STS-102 FLIGHT READINESS REVIEW

February 27, 2001

Orbiter

SEAT BACK CONTROL
LEVER

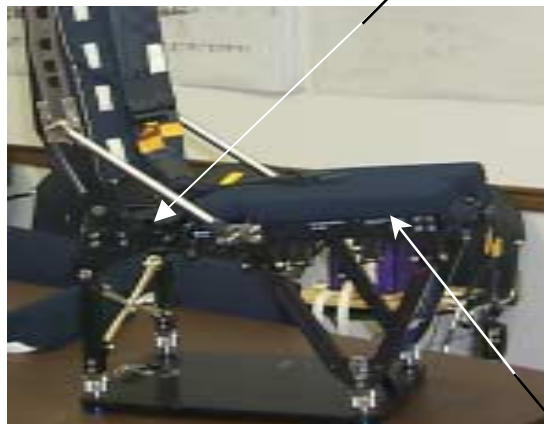
- Eliminates Vehicle/Crew Safety Concerns
(Potential Inability To Reach Flight Controls If Seat
Back Cannot Be Repositioned For Entry)
- Seat Back Angle Control Lever Moved From Right Rear
To Right Front
- Inertia Reel Control Lever Moved From Right Front To
Left Front
- Now Identical To LW CDR/PLT Seats (& HW Seats)

New Configuration
Both Control Levers
Easily Accessed At Front Corners

Old Configuration
Seat Back Control Was Difficult To Reach

**ODS Overview Showing
Centerline Camera Components**

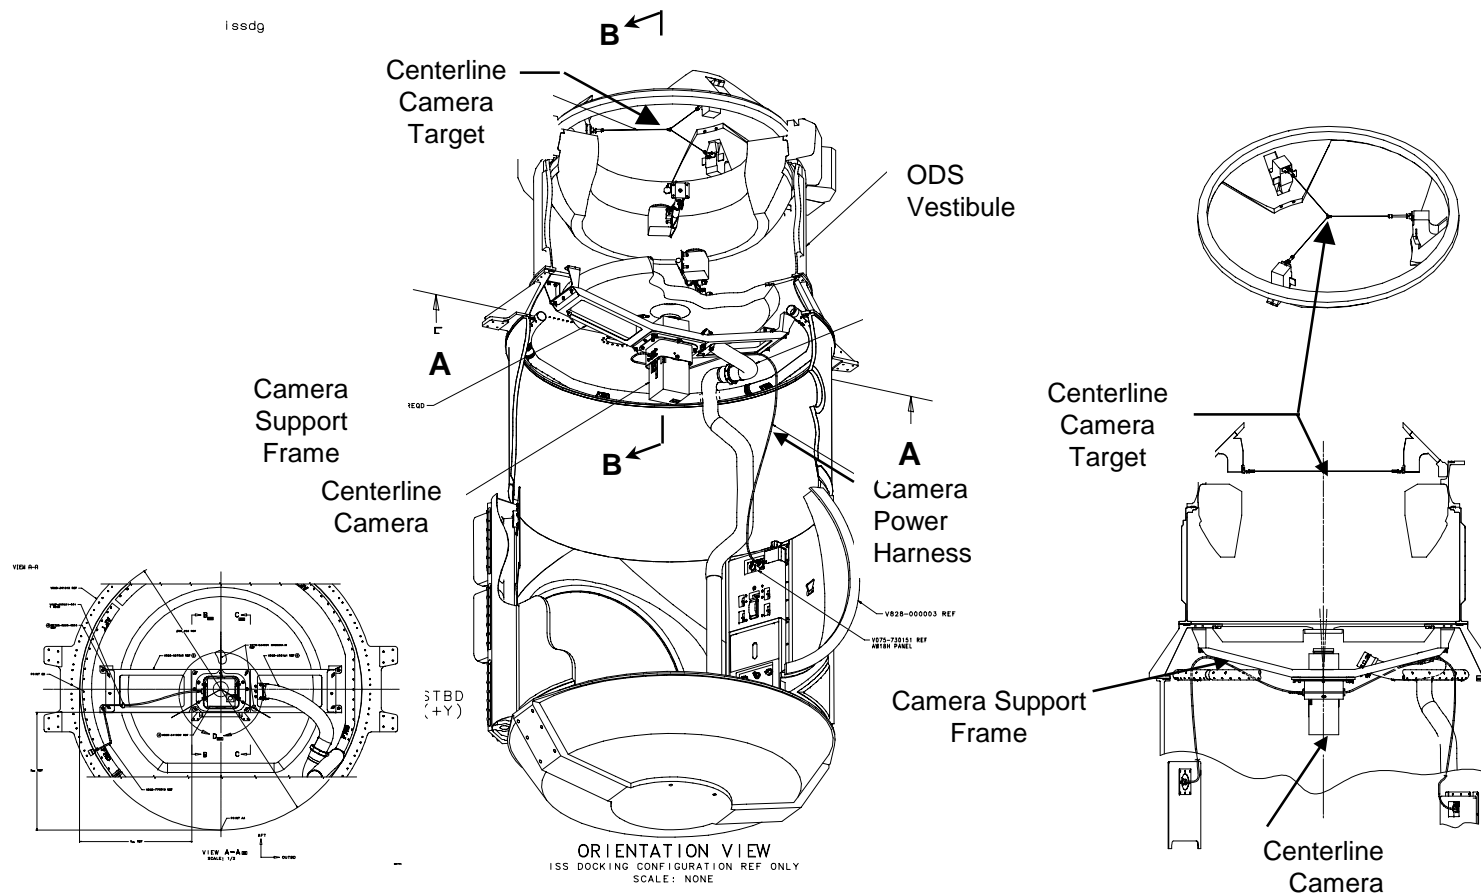
- During preparation for docking the crew reported that the primary ODS C/L camera was misaligned
- The crew removed the primary camera and installed the backup camera, but the misalignment was worse
- The primary camera was reinstalled, docking was allowed to proceed and a successful capture was completed

- Severe centerline camera misalignment could impact docking operations

- Realignment of cameras on OV-103 has been performed and confirmed that both the primary and backup centerline cameras are aligned within specification
- APAS performance capabilities can accommodate camera misalignment larger than that recently observed with no risk to a successful docking

Target Detail View Showing STS-92 and STS-106 Misalignment

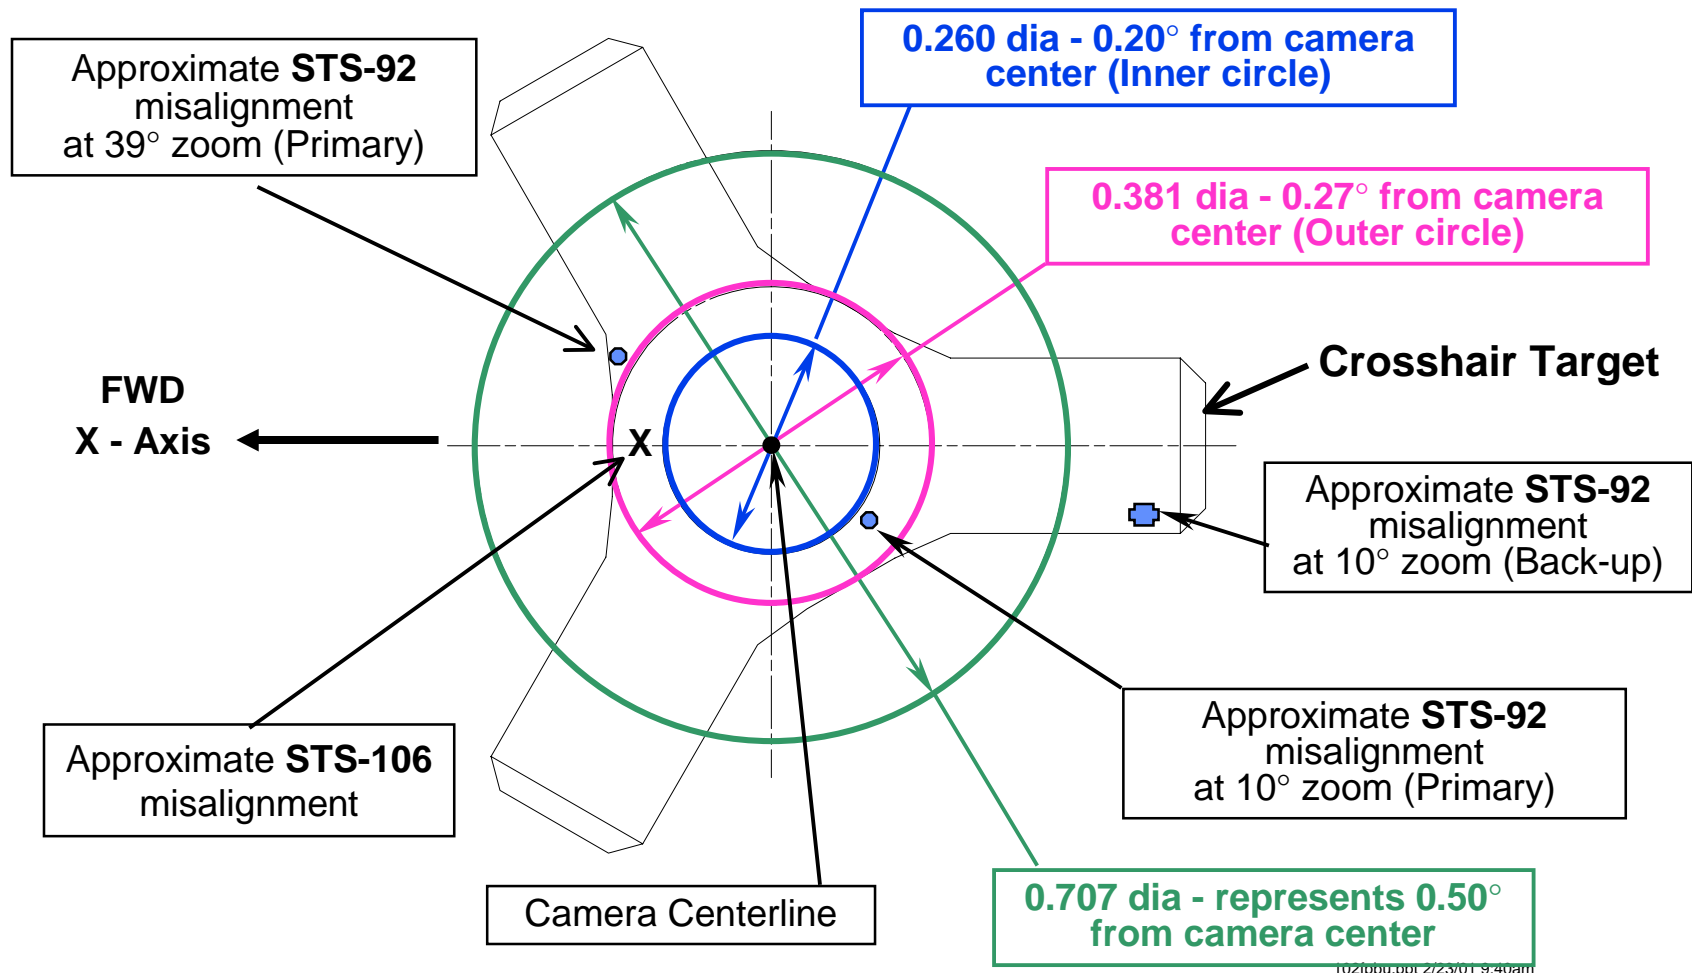
- Misalignment to a similar degree was observed with the primary centerline camera during STS-106 (OV-104) in preparation for docking
- During STS-106 preparations for un-docking, the camera was reinstalled and was observed to be nominally aligned
- The backup camera was not used during STS-106

- APAS capability provides significant margin to accommodate combination of actual docking misalignment and observed centerline camera misalignment
- Slight centerline camera misalignments like those observed during STS-106 and STS-92 had no significant effect on actual alignment at docking

Emergency Egress Platform Installation

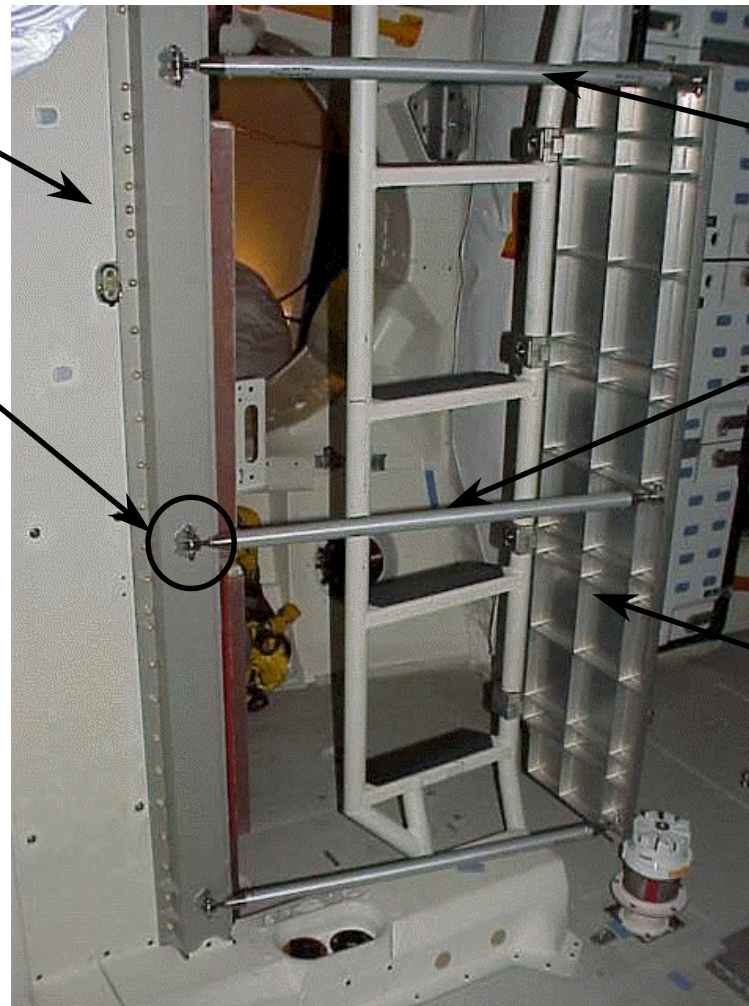
Fasteners at each
of the strut attach
points replaced by
pip pins

Shuttle ARS Ducting Below the Floor:

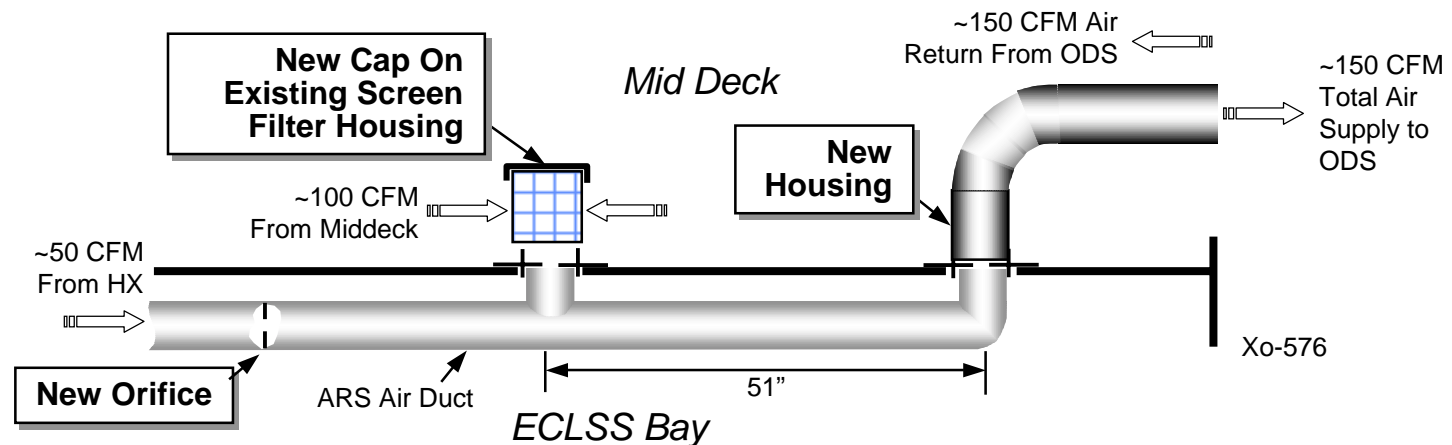
- Previously OV-103 has flown an extended mid-deck floor to external airlock ARS duct configuration for improved ISS/Spacehab air quality
 - Crew installed duct was 51 inches longer and was routed above-the-floor to the forward mid-deck venturi location
- New (permanent) modification provides rerouted air flow below the mid-deck floor
 - Allows returning to the previously manifested shorter duct and connection to the aft venturi location

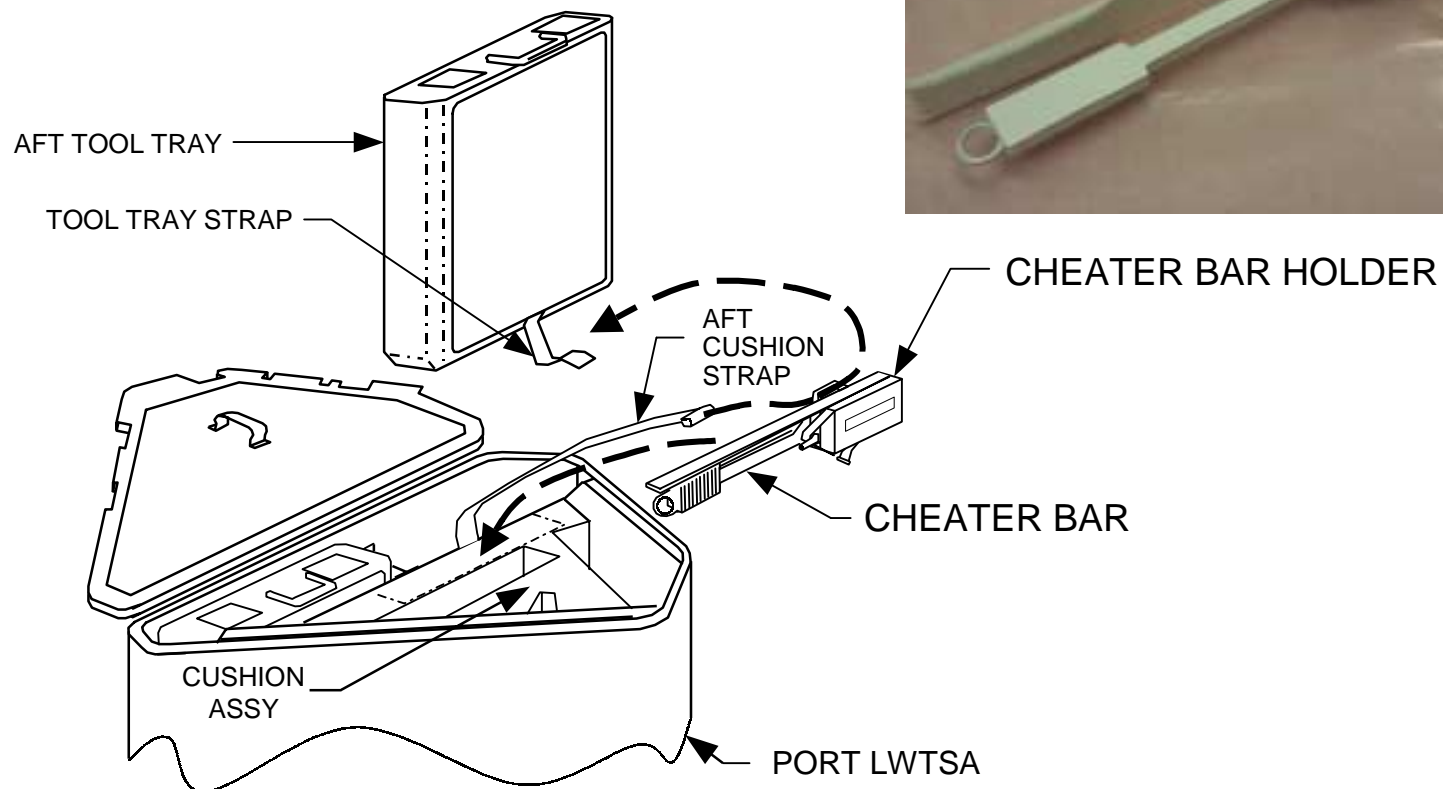
- Cheater Bar / Holder added to LW TSA
- Attaches to LW TSA Cushion Strap
- Integrated Cargo Carrier (ICC) contingency tool

Failed Payload Bay Floodlight No. 4 Mid Starboard

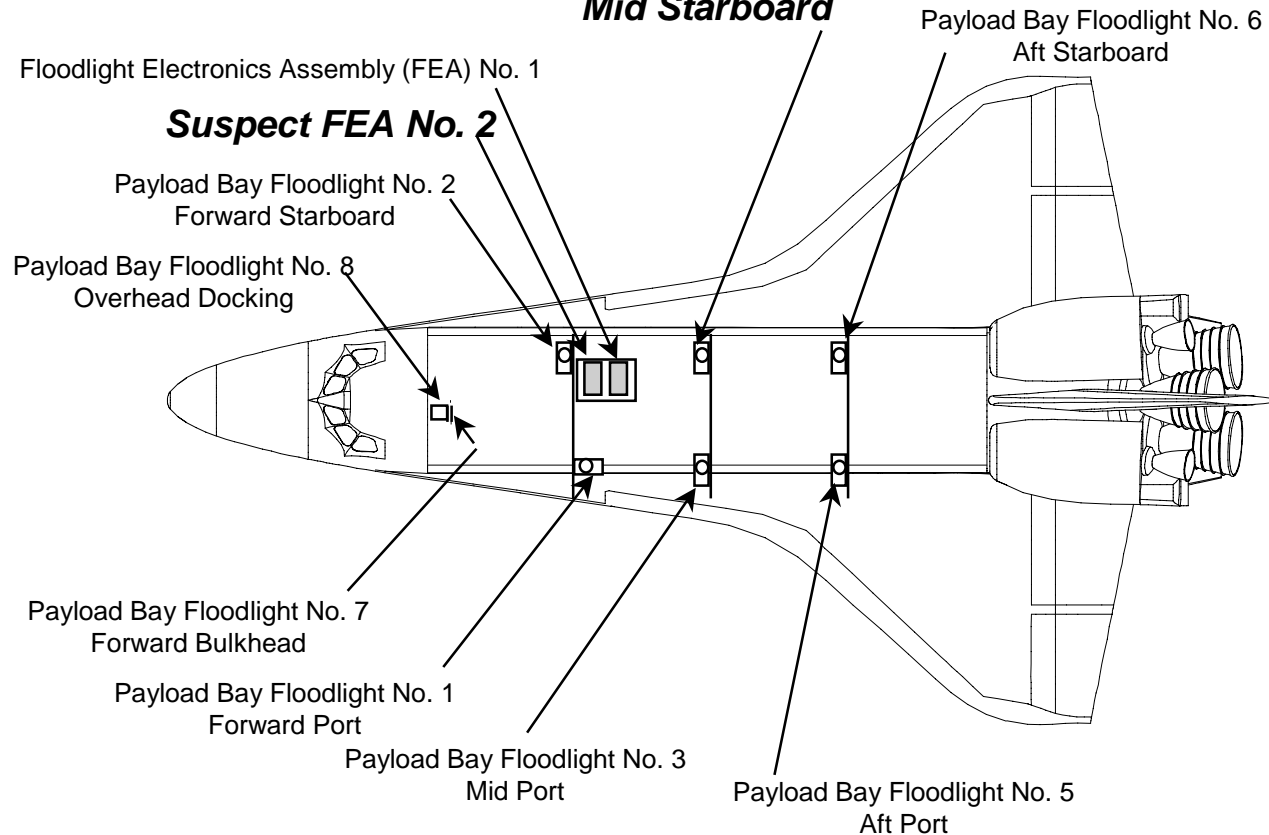
- During payload bay door closure on STS-98 (OV-104), the mid-starboard payload bay floodlight #4 failed to turn on when commanded by crew
 - Current measurements of Main Bus C indicated RPC trip (approx. 14 amp excursion)
 - 10 amp RPC 7 in MPCA #3

- Multiple loss of payload bay floodlights may impact mission success
 - Loss of lighting could cause crew to utilize alternate method (handheld spotlight) for verification of payload bay latch operation

- Adequate system redundancy exists
- Low probability of failure in ballast assembly with modified ballast
 - Last failure of a ballast assembly was in February 1998
- OV-103 payload bay floodlights have successfully passed OMRSD testing

Overview of Payload Bay Floodlight System

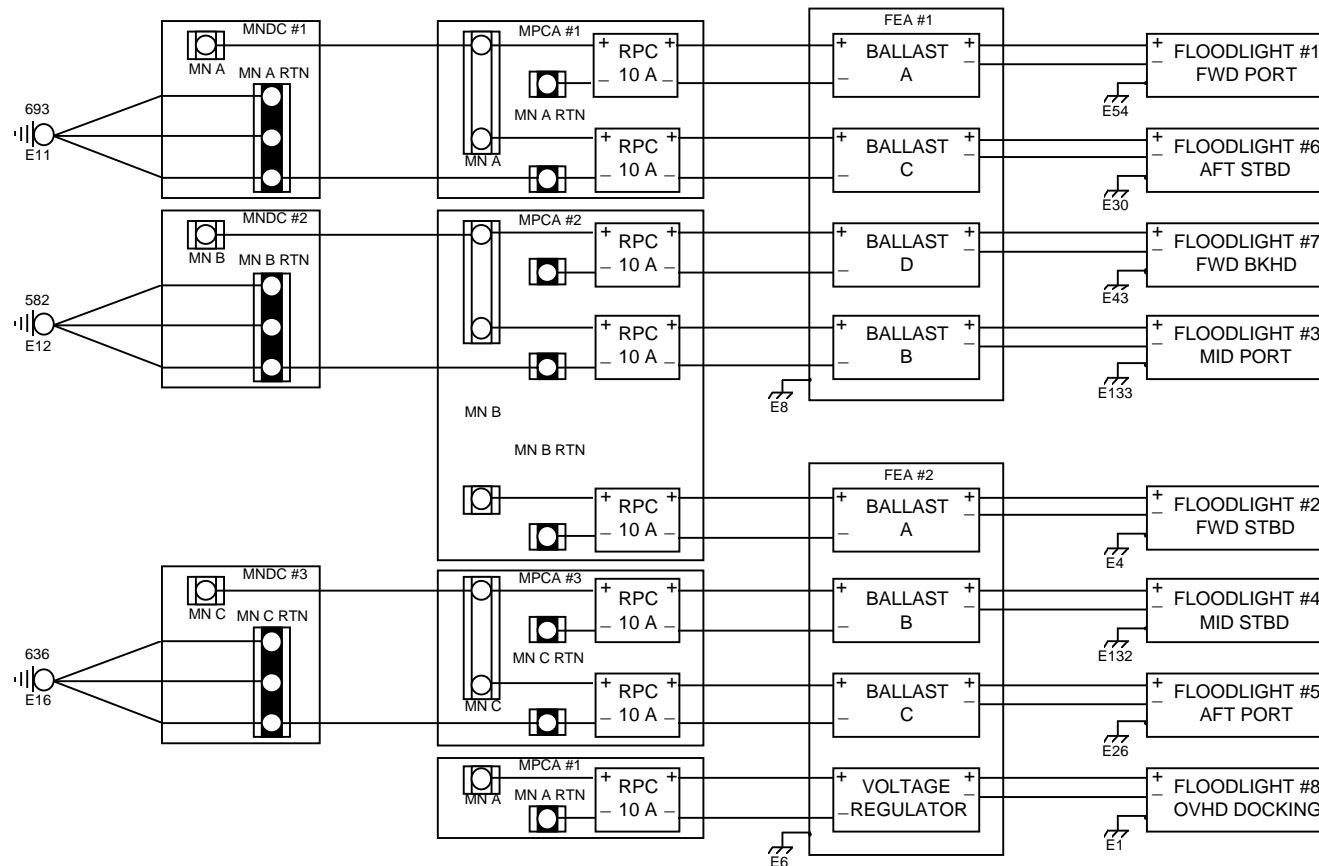
- OV-104 Floodlight Electronics Assemblies (FEAs) are modified and have a current output of 1.3 amps
- FEA #2 provides power to payload bay floodlight #4
- Main Bus C current measurements point to most probable cause for loss of floodlight #4 to be a failed ballast B in FEA #2
 - Another possible cause is corona arcing in floodlight assembly, however current signature is not consistent with arching
- FEA #2 was issued to OV-104 in 1996 in support of flight 16
 - FEA #2 has successfully supported 7 missions prior to STS-98

Current Measurement showing
RPC trip

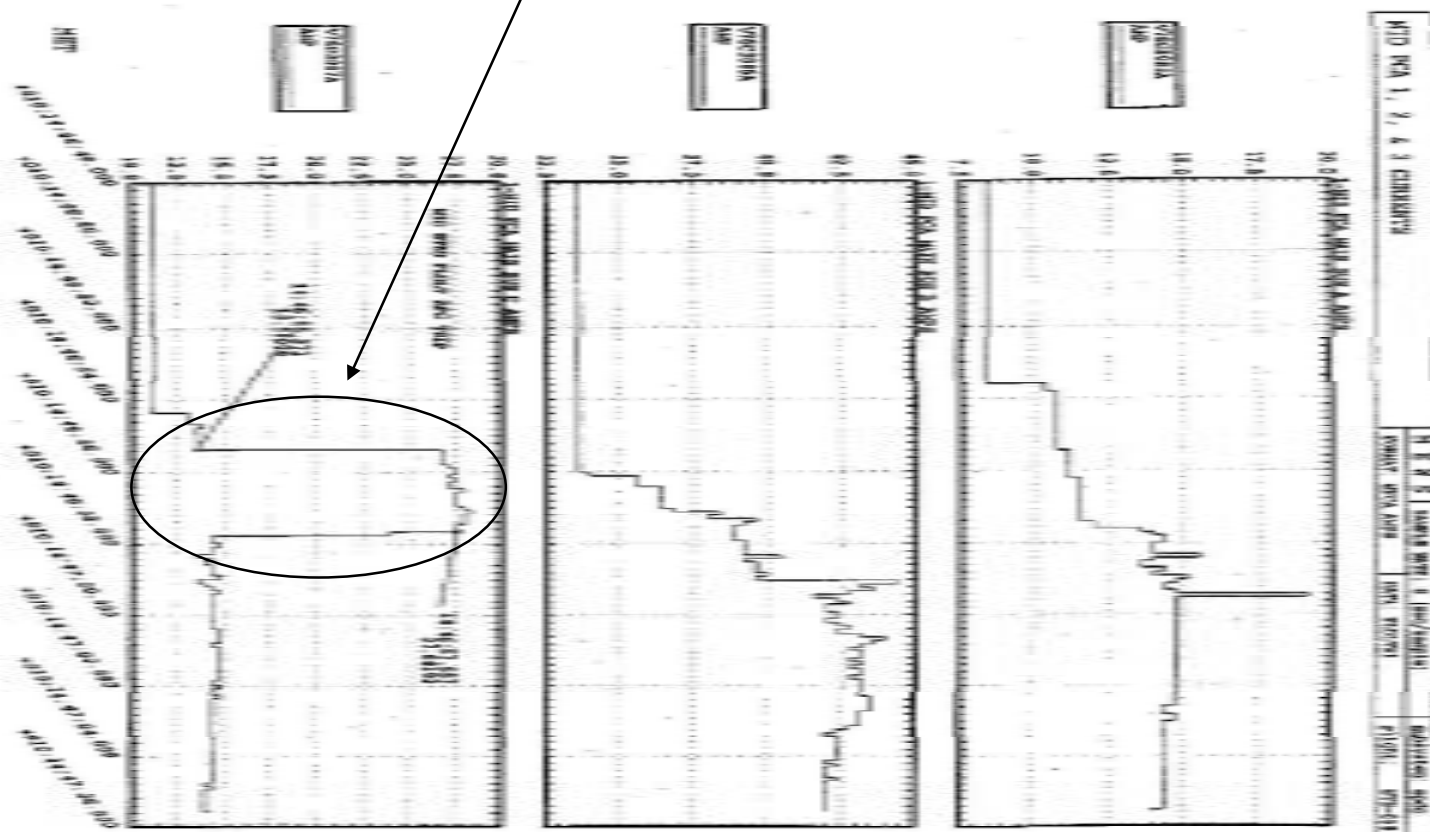
- FEA #2 contains 3 ballast assemblies and 1 voltage regulator
 - Each ballast assembly powers its own individual floodlight
 - Voltage regulator is used to power overhead docking floodlight
 - Failure of one ballast will not affect other ballasts or regulator
- Most likely component failure in ballast assembly is the transistor Q6
 - Failure of transistor Q6 is usually a collector to emitter short due to electrical overstress
 - Transformer T1 in ballast assembly may be a contributing factor to the overstress of transistor Q6
 - Transformer T1, due to a marginal design of its “fly-back” operation, tends to become saturated causing Q6 overstress

Organization/Date:
Orbiter/02-27-01**Deployed Assembly (DA) Hardware Overview**

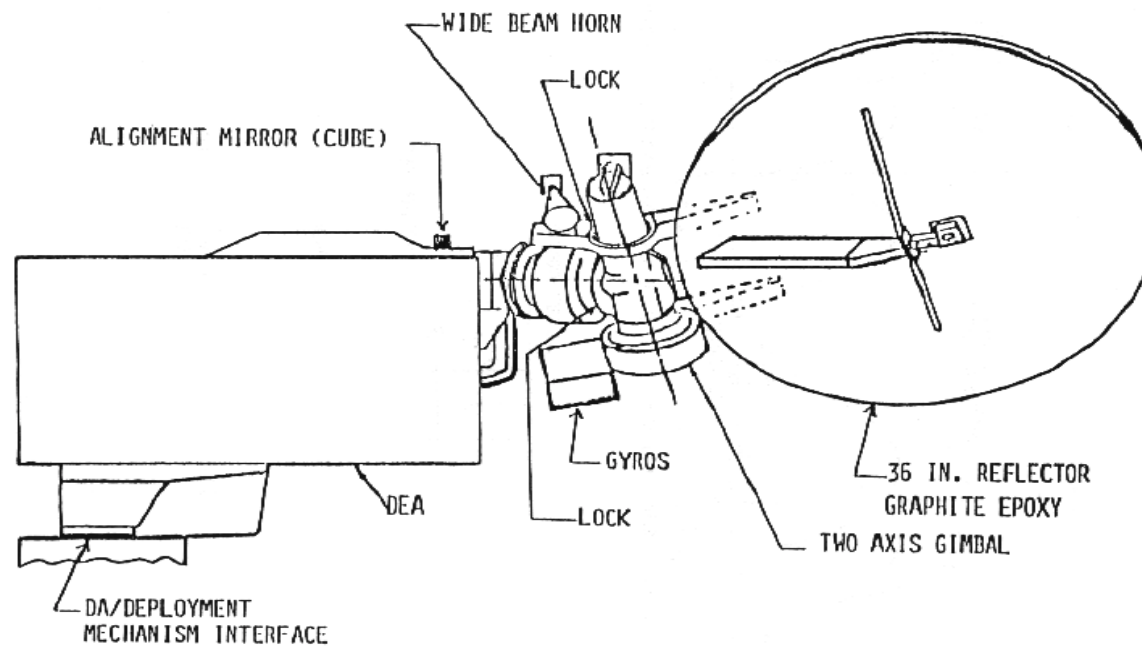
- During STS-92, OV-103's Ku-Band system did not operate in Comm or Radar mode

- Loss of Ku-Band Comm mode results in loss of real-time video and high data rate downlink capability
- Loss of Radar function requires utilization of workarounds for rendezvous and docking operations

- Post-flight troubleshooting determined that the cause of problem was within the DEA Exciter circuitry
 - The Ku-Band DA (S/N 102; which includes the DEA) was removed on 11-20-00 and sent to NSLD for failure isolation and repair
 - Troubleshooting confirmed to the component level
 - Q5 transistor on the A3A1 Harmonic Phase Comparator Circuit Card was found to be bad
 - Transistor had an open Base-Emitter junction which prevented conduction and subsequently phase-lock within the DEA
 - Component was removed and replaced
 - DEA will undergo solder rework

- Discrepant OV-103 Ku-Band system hardware has been removed and replaced with a flight spare
- Comm and radar workarounds are available
- All Ku-Band system OMRSD testing has been successfully completed
